**Addendum # 1**  
**Solicitation # 20-99322**  
**Project: Second Street Reconstruction**

This addendum serves to notify all bidders of the following changes to the solicitation documents:

E. SECOND STREET RECONSTRUCTION  
CITY OF DULUTH  
CITY PROJECT NUMBER 1851

SEDIMENT STRUCTURE - 7TH

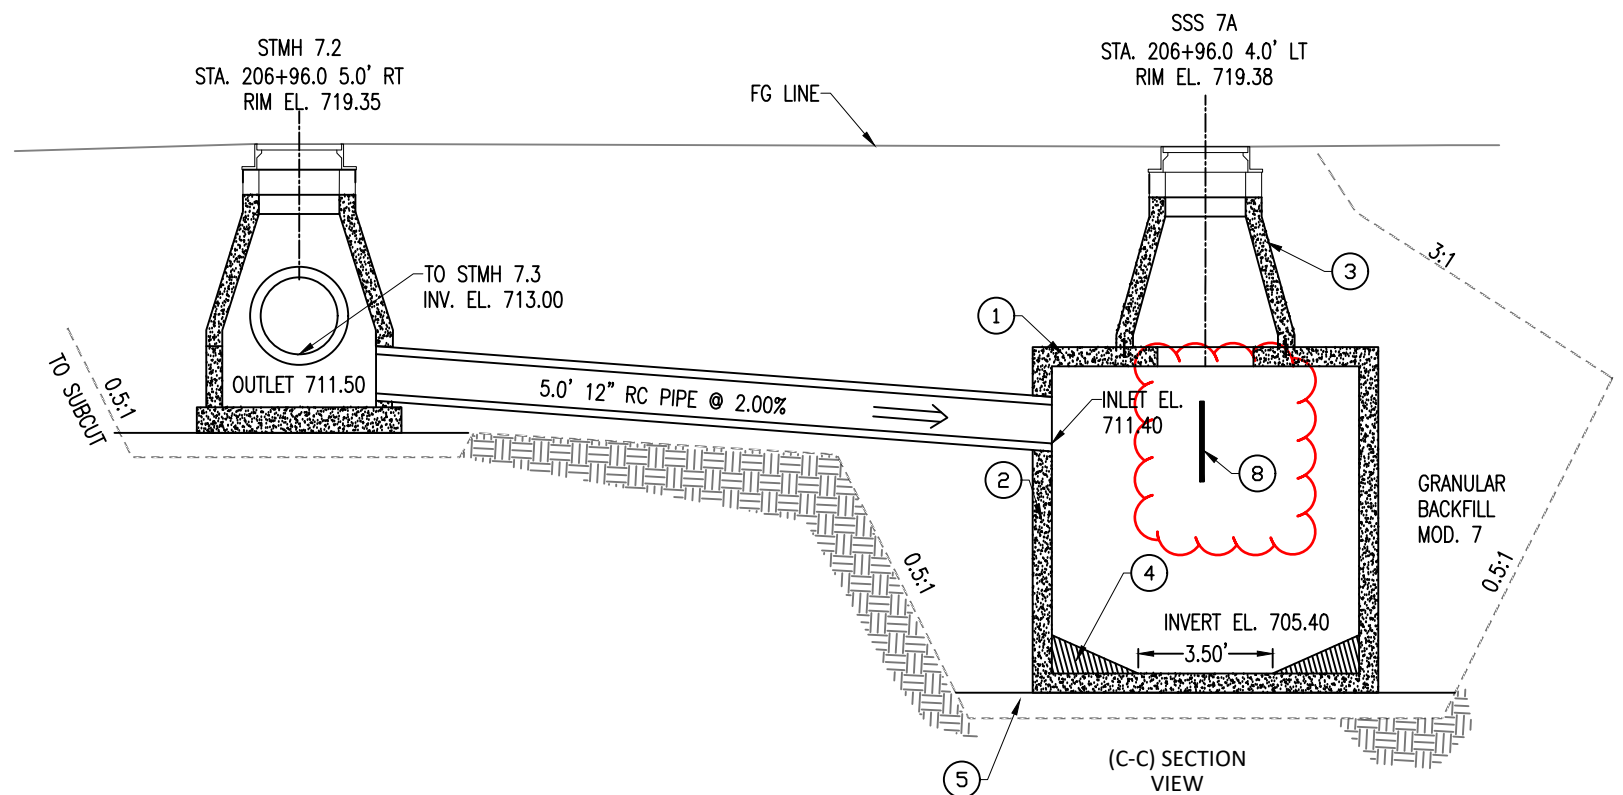
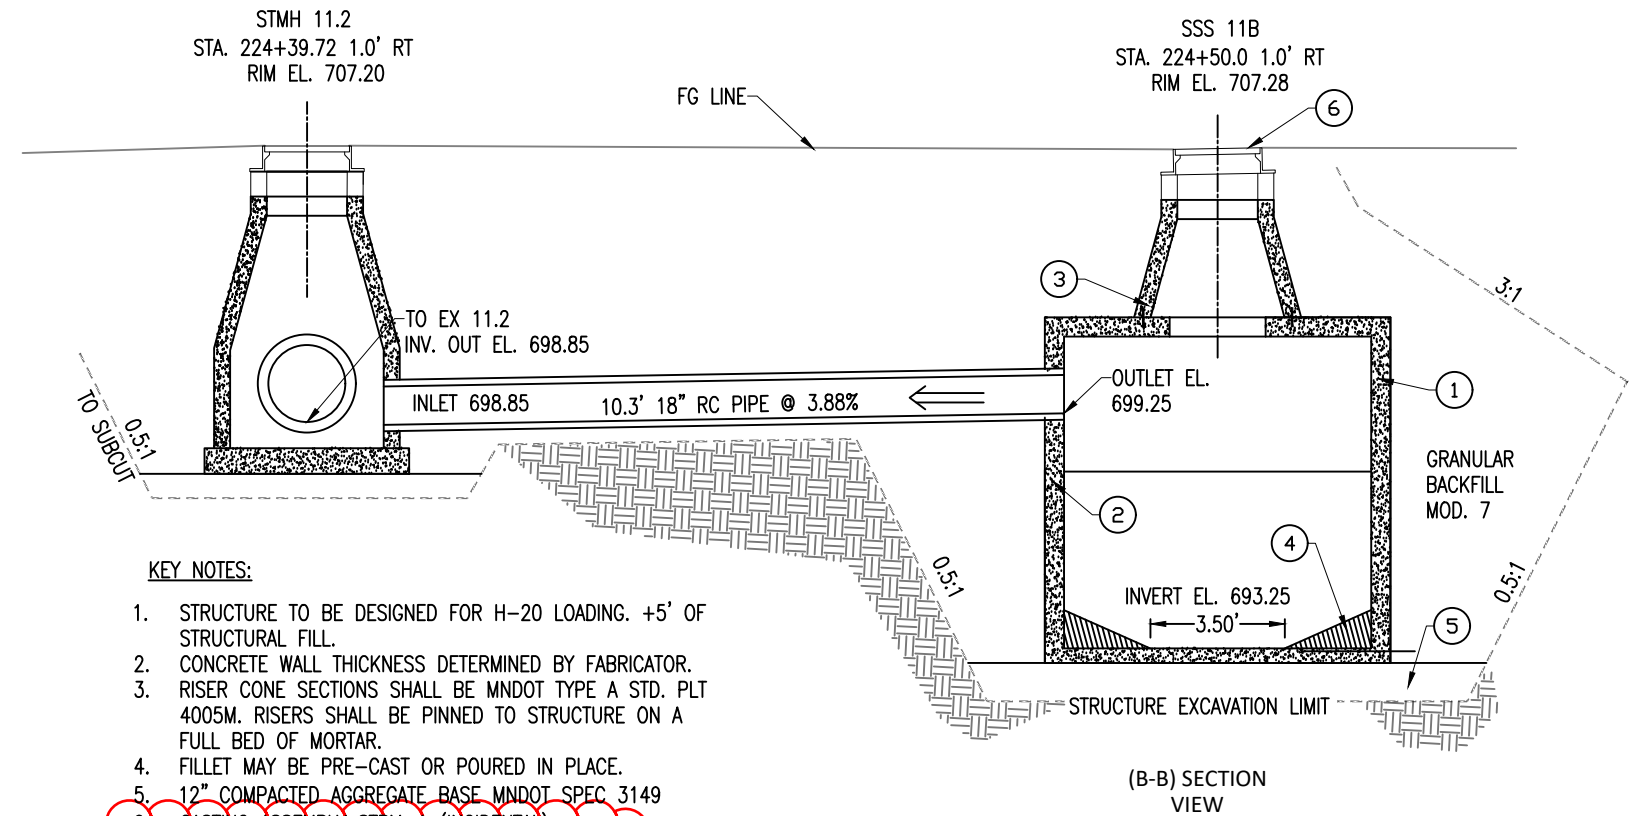
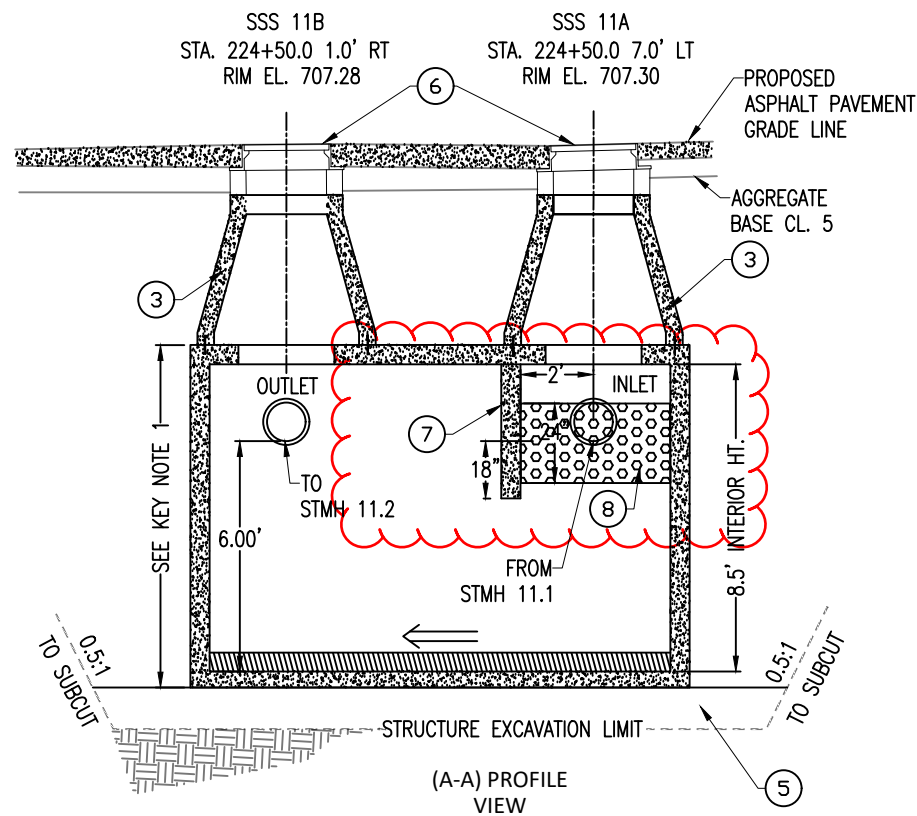
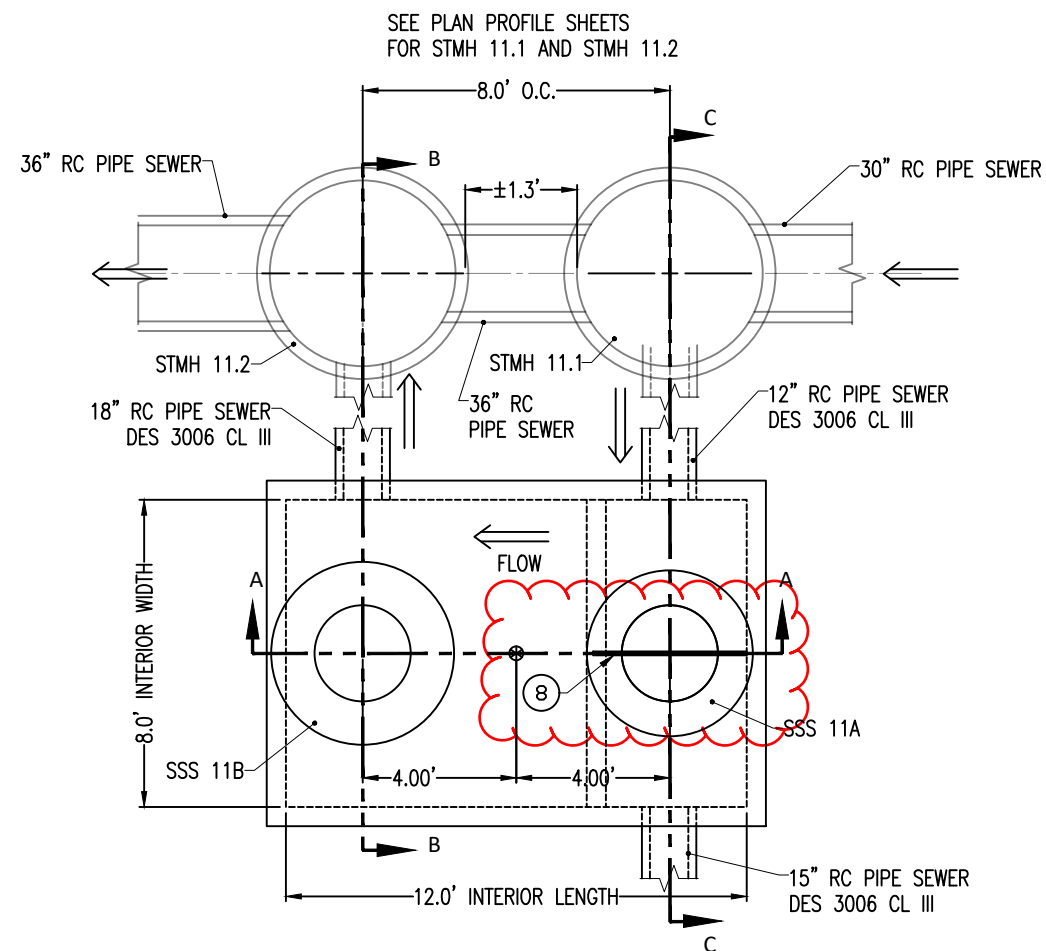
3. *Sheets 68 & 69 are removed and replaced with the attached sheets. These sheets include additional detail for the Storm Sewer Sediment Structures.*
